## CITY OF ALBUQUERQUE

Re: Montage 7 Tracts A-1-A-5-C Mesa del sol Innovation Park Traffic Circulation Layout Engineer's Stamp 03-13-23 (R16-D100A)

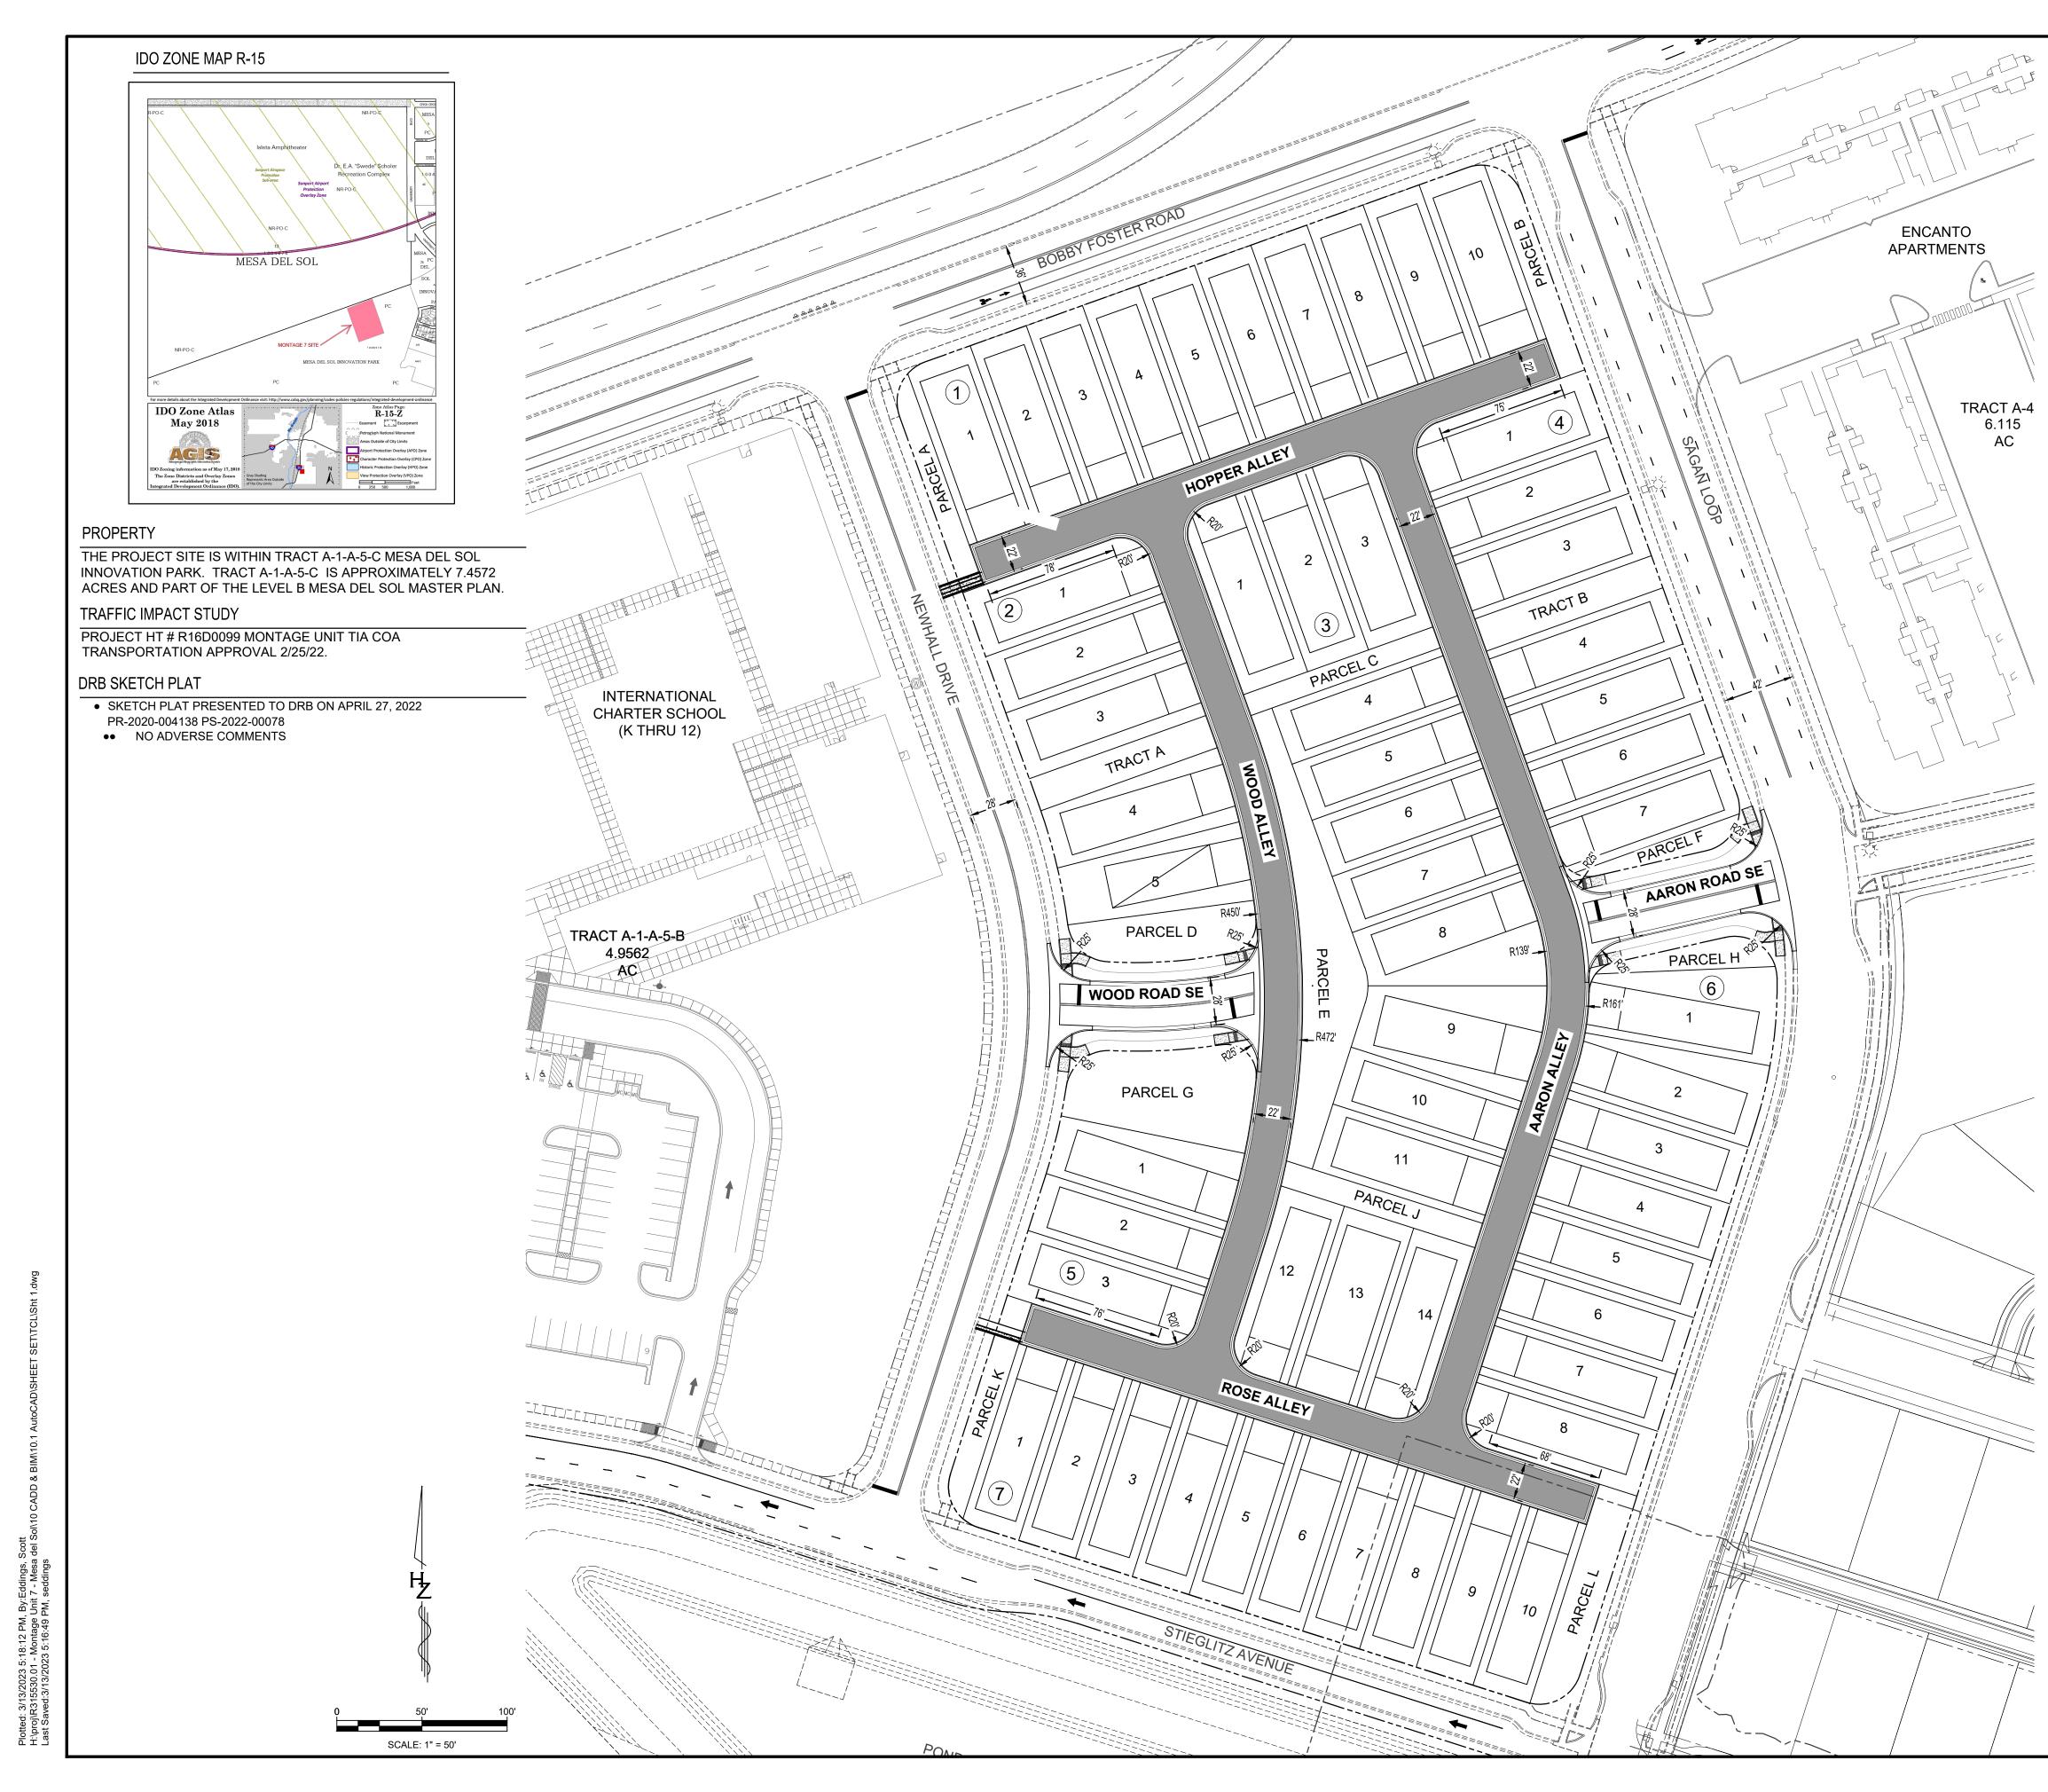
1. Identify all existing access easements and rights of way width dimensions.

2. A 5 ft. wide sidewalk must be built from property line to property line along Newhall Dr. and Stieglitz Ave. and Sagan Loop.

- 3. A 6 ft. wide sidewalk must be built from property line to property line along Bobby Foster Rd.
- 4. Please provide sidewalk details and reference COA std dwg 2430.
  - 5. ADA curb ramps must be built to current standards at the four corners of the site and at the site accesses and have truncated domes installed.
  - 6. Please call out ADA ramps location, details, and reference COA std.

7. It is not apparent what type of pavement surface is being proposed for Hopper Alley, Wood Alley, Aaron Alley, and Rose Alley. A hard driving surface will be required as part of this proposed project.

- 8. Please show on the site plan the Intersection clear sight triangle at the four corners of the site, and on the site access off Sagan Loop.
- 9. Show the clear sight triangle at the site access off Newhall Dr.
- 10. Please add the following note to the plan: "Landscaping and signage will not interfere with clear sight requirements. Therefore, signs, walls, trees, and shrubbery between 3 and 8 feet tall (as measured from the gutter pan) will not be acceptable in the clear sight triangle.
- 11. Please provide a copy of Fire Marshal approval.
- 12. Please specify the City Standard Drawing Number when applicable.
- 13. Work within the public right of way requires a work order with DRC approved plans.
- 14. Please add a note on the plan stating "All improvements located in the Right of Way must be included on the work order."
